**STATE OF CALIFORNIA
REGIONAL WATER QUALITY CONTROL BOARD
CENTRAL COAST REGION**

STAFF REPORT FOR REGULAR MEETING OF JULY 10, 2009

**SUBJECT: REGULATION OF TIMBER HARVEST ACTIVITIES IN THE CENTRAL
COAST REGION**

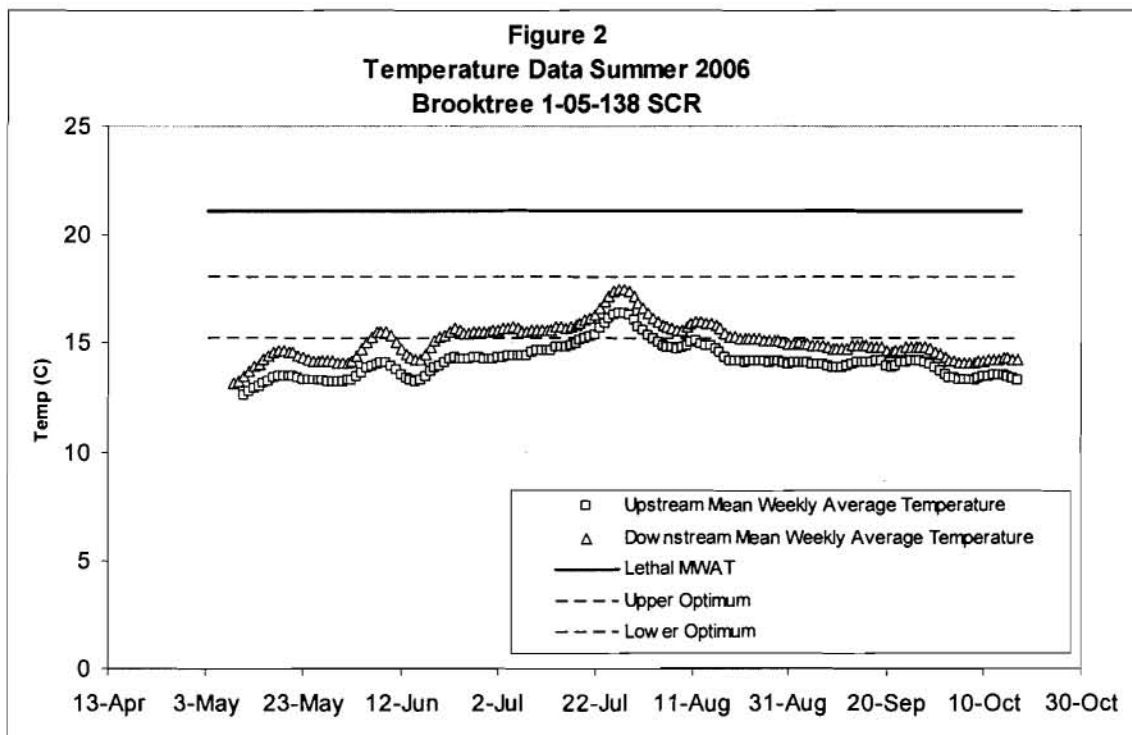
- 23. Comment:** The staff report states that in every case, water temperatures downstream of logging operations were warmer than upstream.

- 27. Comment:** These data also indicate that for a majority of timber harvesting plans, regardless of whether temperatures are within suitable thresholds, water temperatures at the downstream monitoring points often exceed water temperatures at the upstream monitoring points. While it is not possible to determine the extent to which these effects should be attributed to harvest operations, it indicates that there is potential for such effects.

- 30. Comment:** The statement in the waiver staff report that 18% of the data sets indicated that water temperature exceeded the proposed optimal range indicates that logging may have negative impacts on fish habitat.

Response: Water Board staff reported results incorrectly in this case. After reevaluating the data, staff has revised this statement to, "Seventy percent of the data sets showed the downstream temperatures warmer than the upstream counterparts and thirty percent of the data sets showed a mix of downstream temperature warmer than upstream and vice versa."

Response: Water Board staff concurs that it is not possible to determine the extent to which temperature effects should be attributed to harvest operations. In the absence of reliable preharvest data and considering the limitations and constraints of temperature monitoring in general, it is not possible to determine if downstream monitoring points exceeding water temperature at their upstream counterparts is a natural phenomenon, the result of anthropogenic influences, or a combination of each. In any case, since the downstream levels do not indicate risk to fish, staff finds it appropriate to modify temperature monitoring requirements.

Response: Water Board staff concurs that when water temperature exceeds the optimal range for salmonids instream conditions may have negative impact on fish habitat. Water Board staff disagrees that this provides evidence that logging is the source of the negative impacts. Due to limitations and constraints in the temperature data it is difficult to determine the source of potential temperature exceedances, see comment response to #27 above.
